RFP 2016-0009 - ADDENDUM 3

COLIGNY REDEVELOPMENT PROJECT

Town of Hilton Head Island, South Carolina

Date Issued: August 5, 2016

1 A1.121 SLAB EDGE PLAN
1/8" = 1'-0"

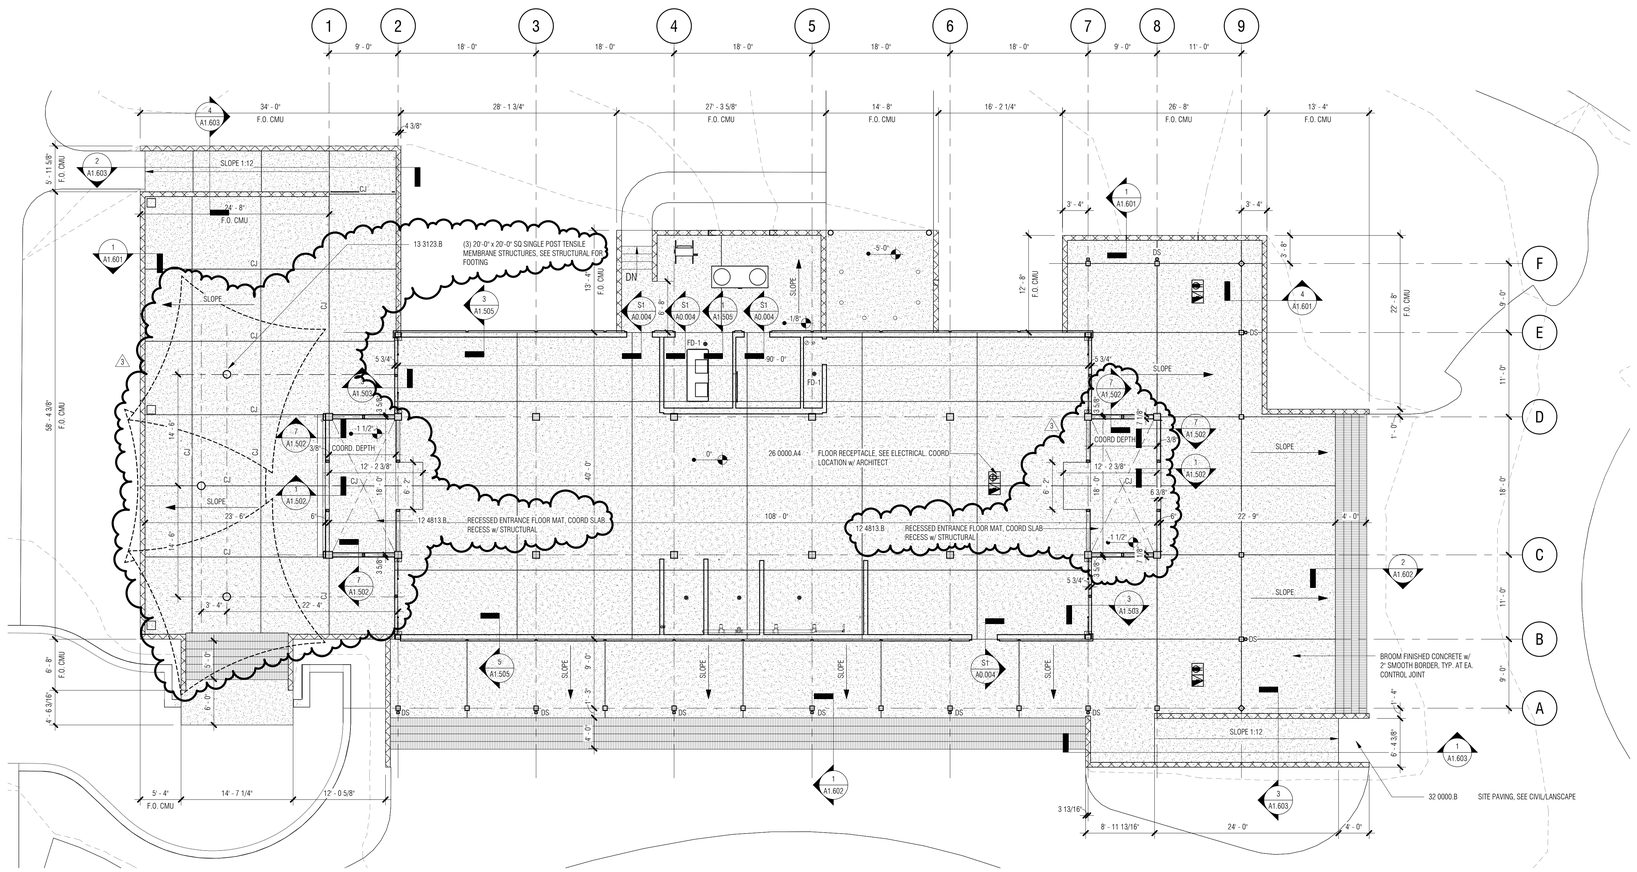
3.10 SHEET A1.121

A. Added shade structures and foundations at playground area outside
   1. south entrance.
B. Added recessed entrance mats at both entrances

SHEET NUMBER
A1.201

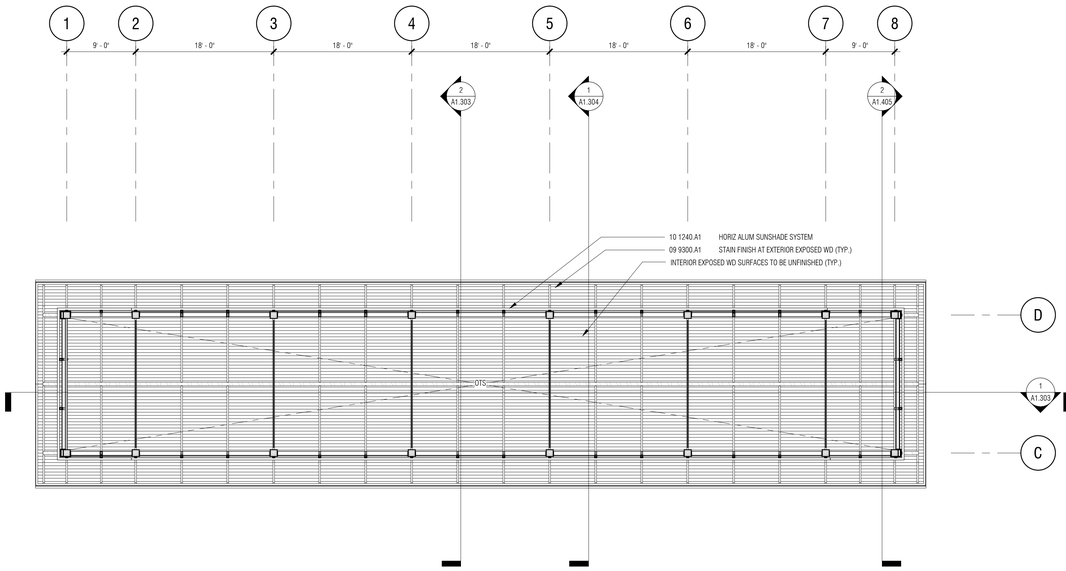
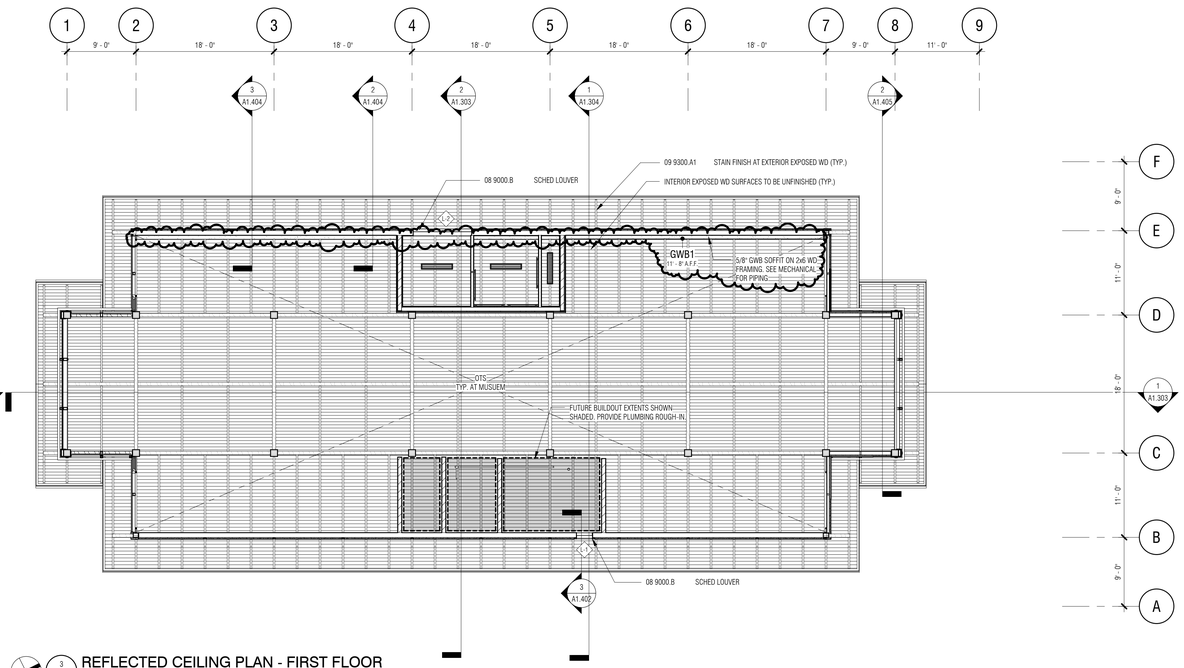
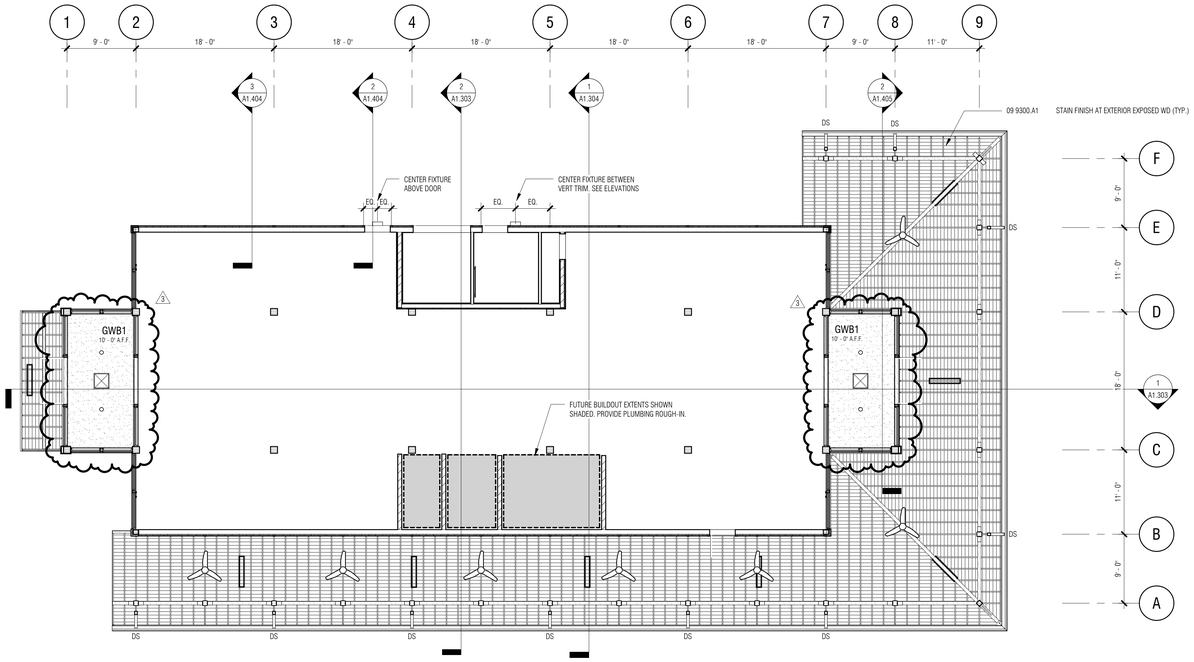
3.11 SHEET A1.201

A. Added gypsum wall board ceiling at both entrances
B. Added gypsum wall board soffit at west exterior wall at mechanical
   1. piping.

SHEET NUMBER
A1.303

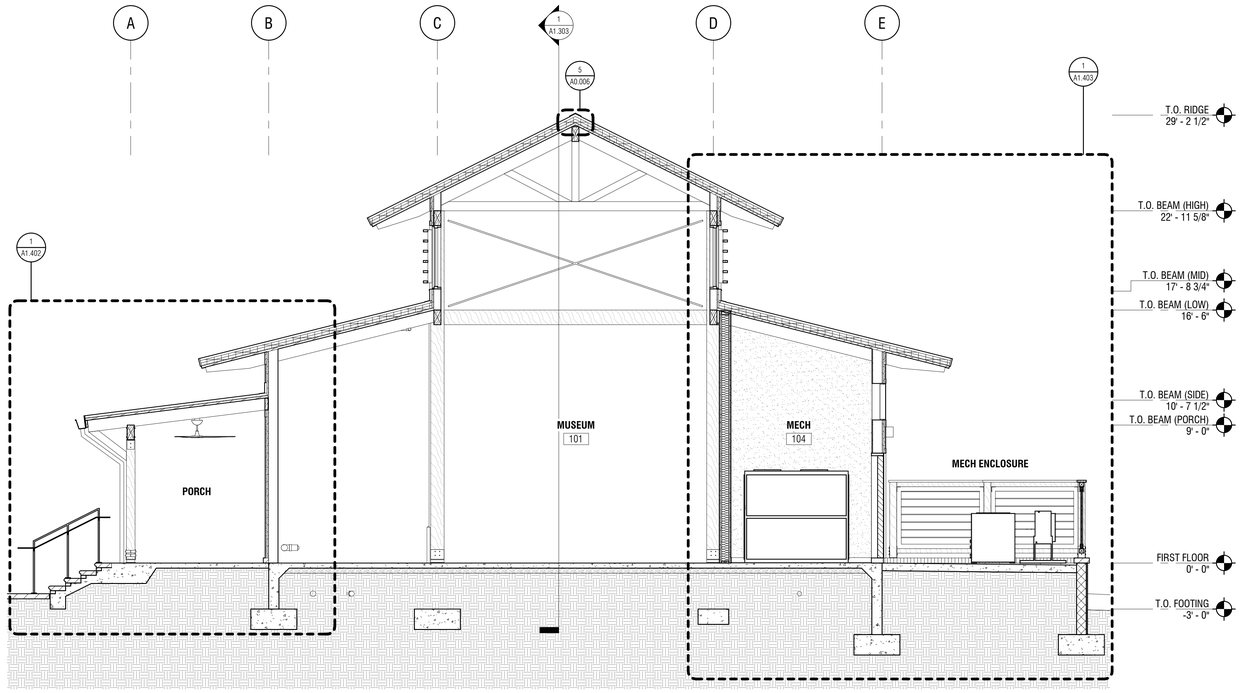
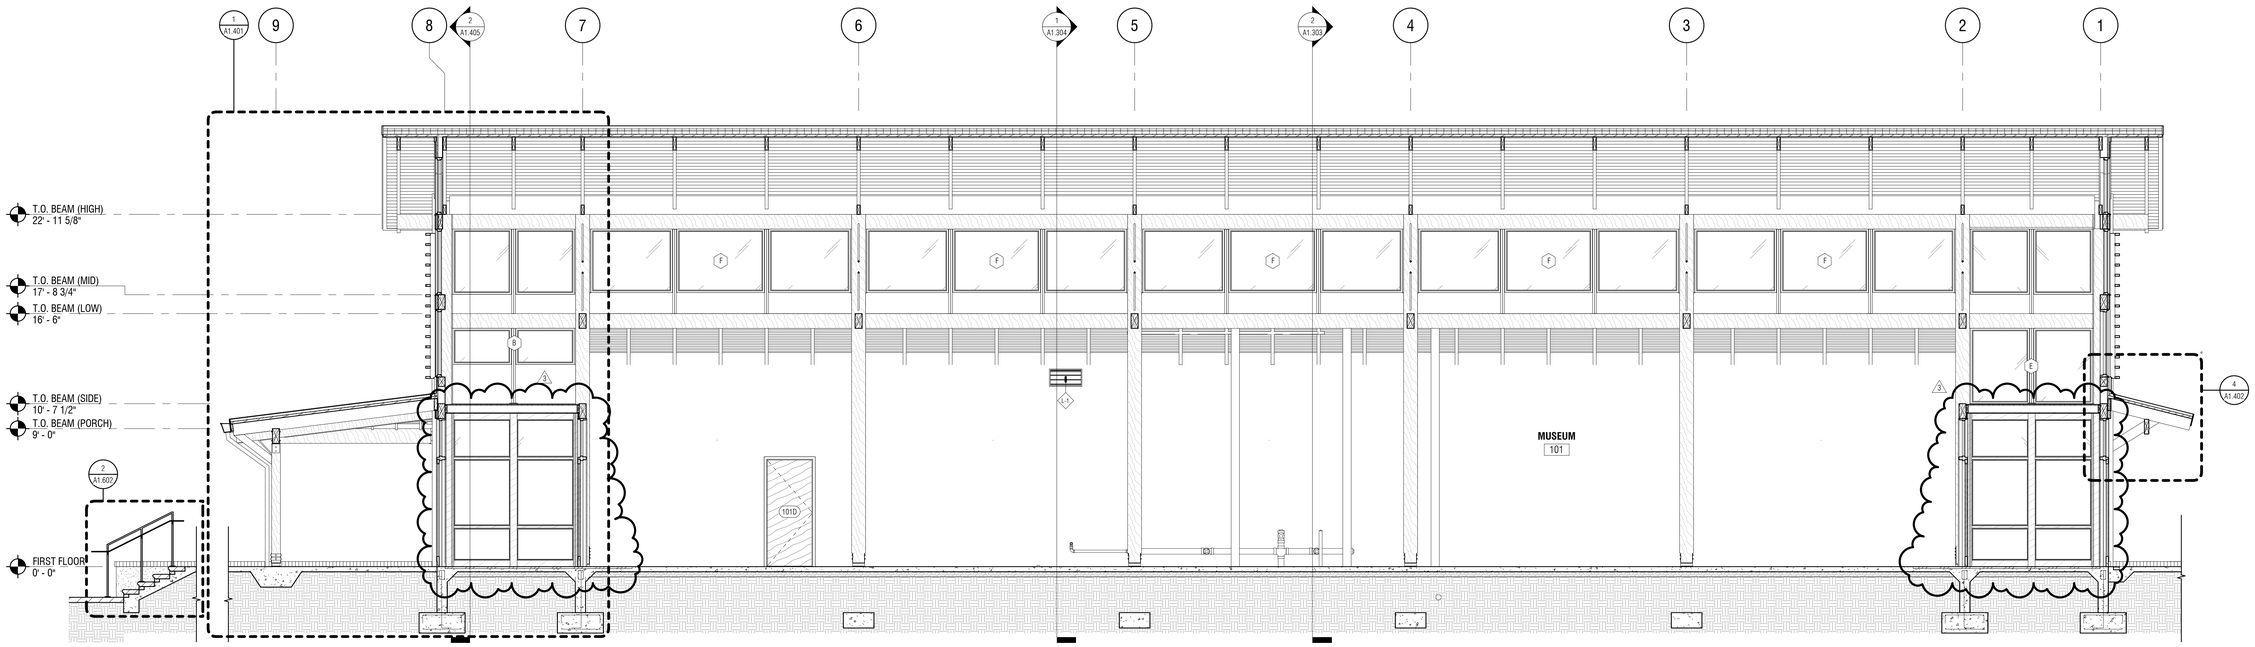
3.12 SHEET A1.303

A. Added Door 100A, stained wood trim, and gypsum wall board ceiling and framing at north entrance.
B. Added Door 100B, stained wood trim, and gypsum wall board ceiling
   1. and framing at south entrance.
C. Added recessed entrance mat at both entrances.

SHEET NUMBER
A1.304

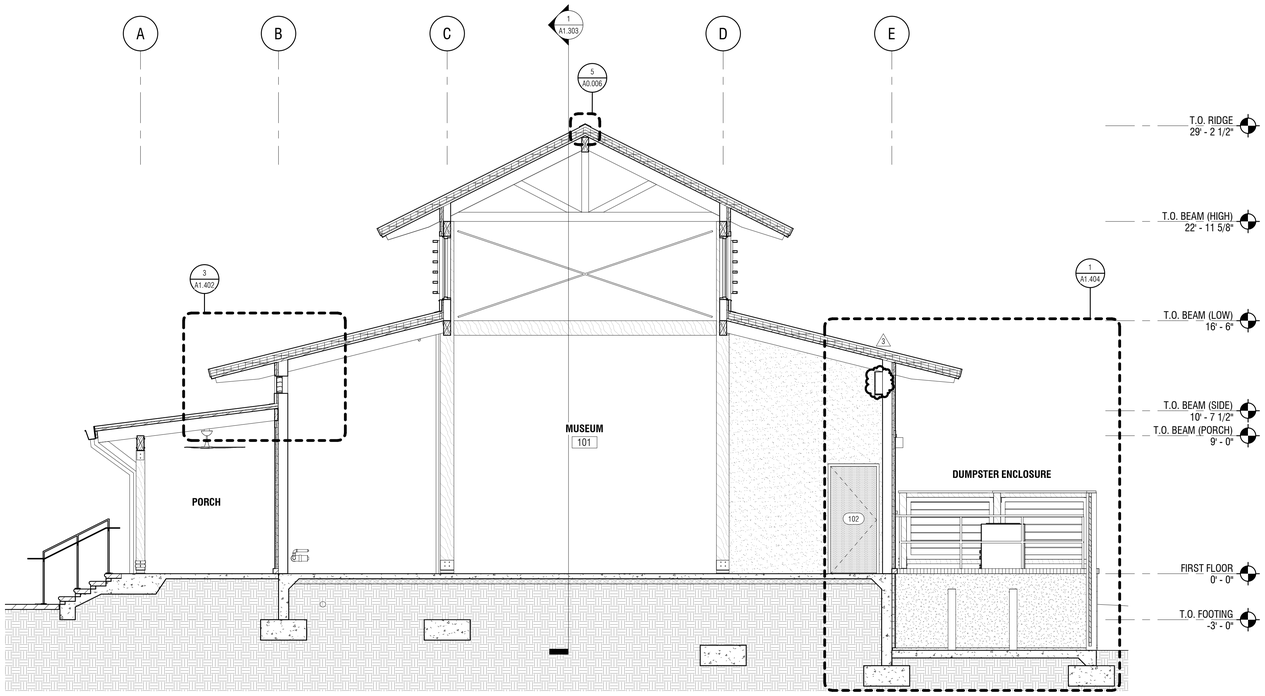
3.13 SHEET A1.304

A. Added gypsum wall board soffit at west exterior wall at mechanical
   1. piping.

1 A1.401 WALL SECTION - EAST ENTRANCE
3/4" = 1'-0"

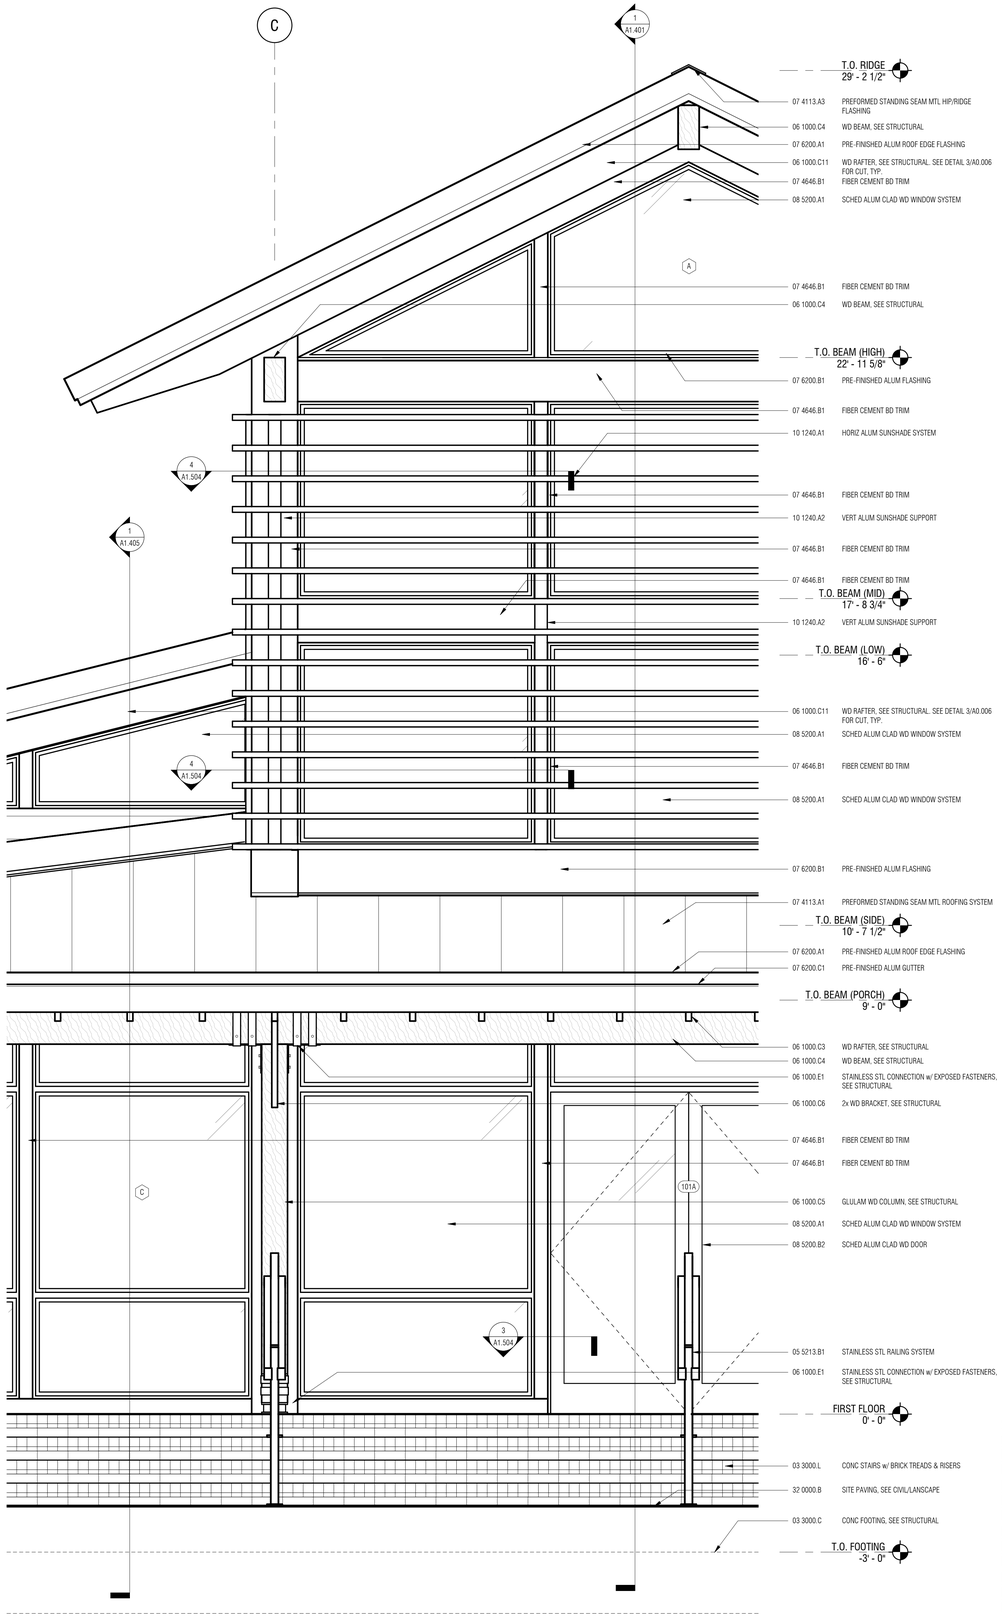
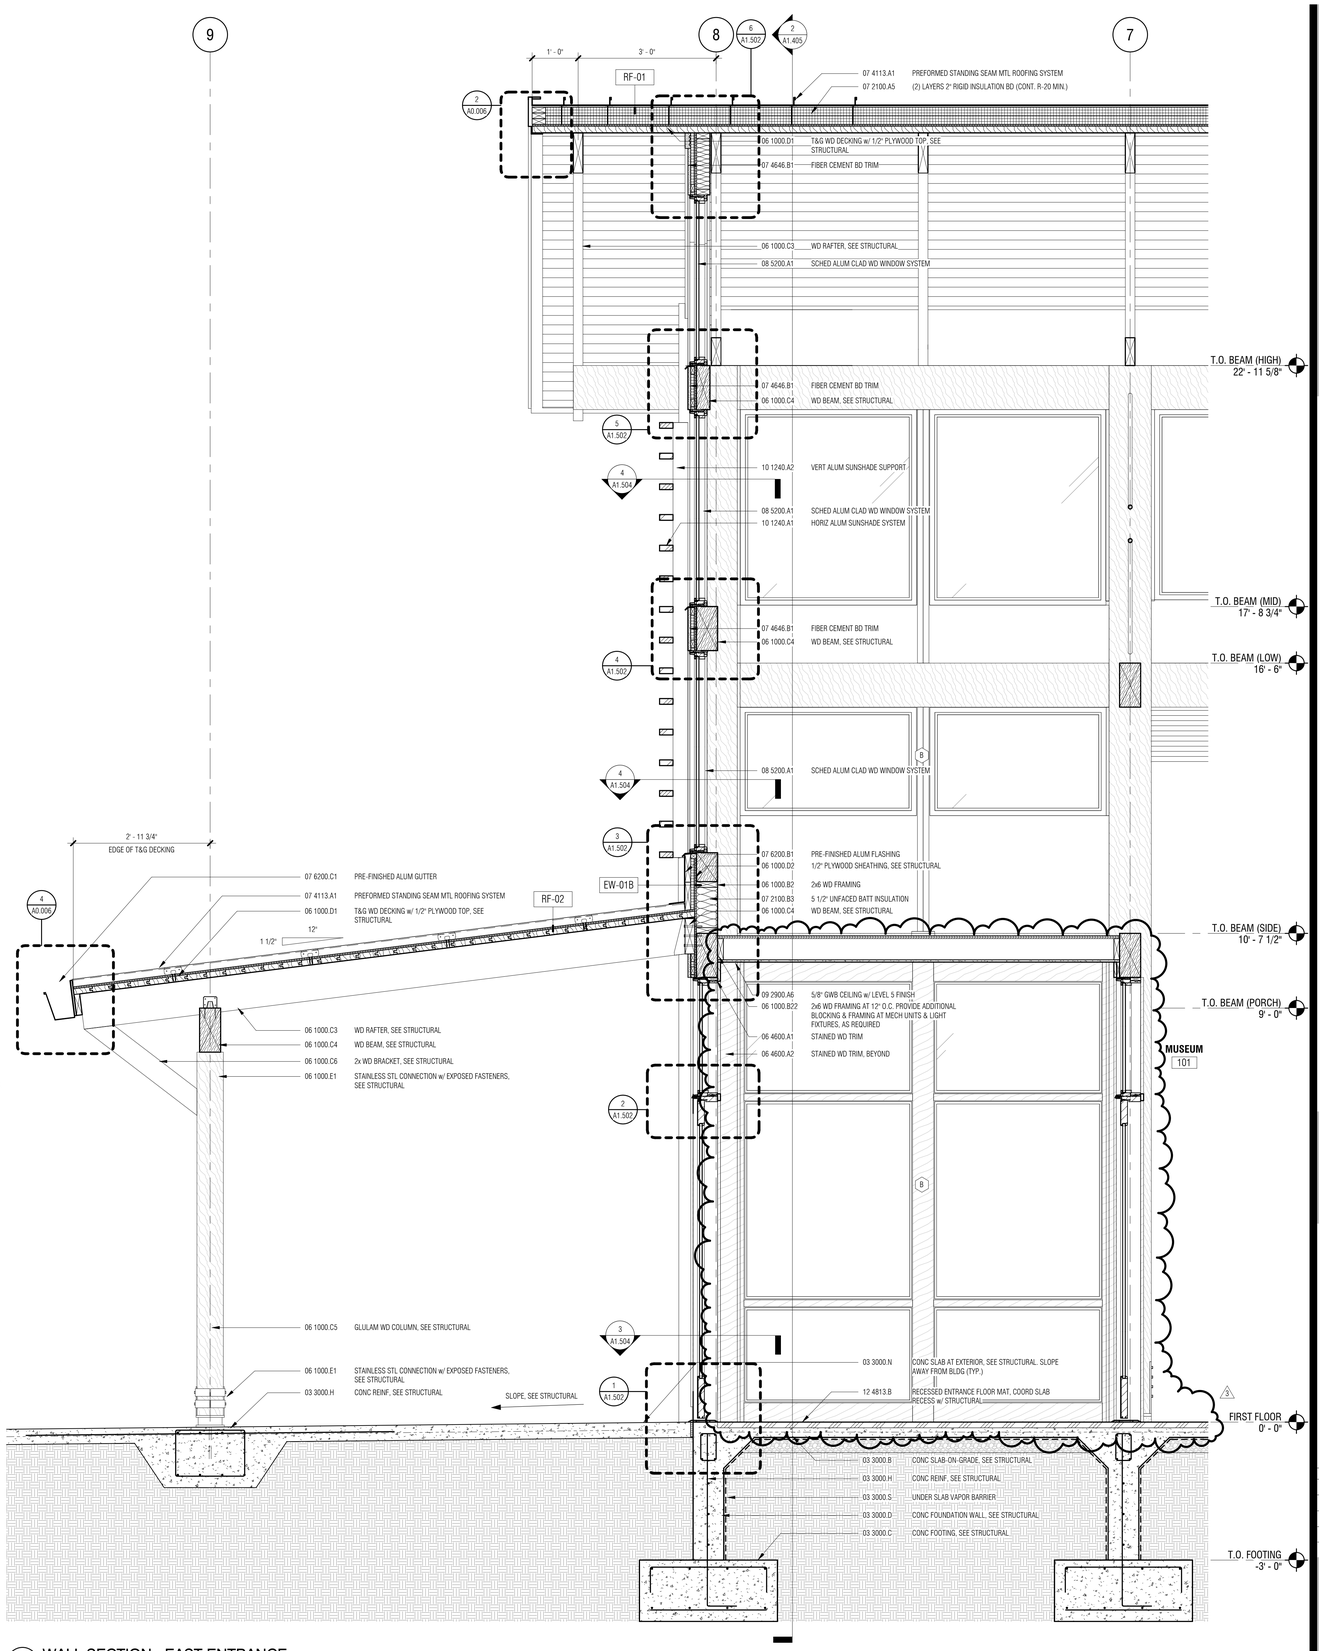
3.14 SHEET A1.401

A. Added Door 100A, stained wood trim, and gypsum wall board ceiling and framing at north entrance.
B. Added recessed entrance mat at entrance
